service bulletin

No. 91-28

Power Trim Relay Inspection – 1992 50 and 60

1992 50 and 60 Power Trim Models

a - Power Trim Relay
b - Relay Production Date Code

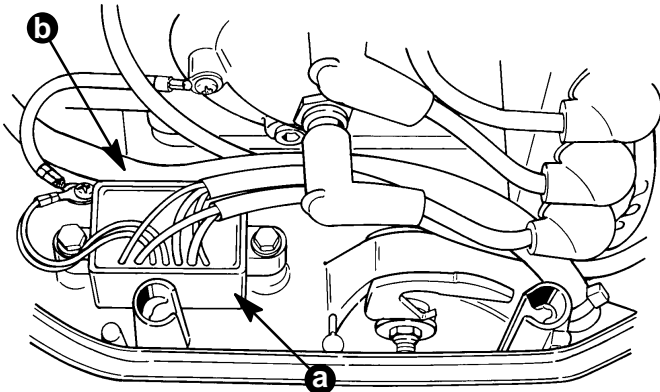
A quantity of power trim relays may have the potential to electrically short circuit and overheat the relay anytime the outboard is connected to a battery. As soon as possible, disconnect the battery and inspect the power trim relay on the outboards listed that have been delivered to the customer, rigged and/or are in your possession.

Replace any power trim relay that has a production date code 1071 thru 1771 printed on the case. The power trim relay is mounted in the rear port side of the lower cowl.

Outboards within the serial number range listed that have been reworked at the factory have the latest relay installed and do not require inspection. Reworked outboards are identified two ways.

- A 1-3/8 inch (35 mm) red ink square placed next to the Mariner or Mercury name on the serial number label on the outside of the shipping carton.
- The power trim relay has a white "X" on the potting material.
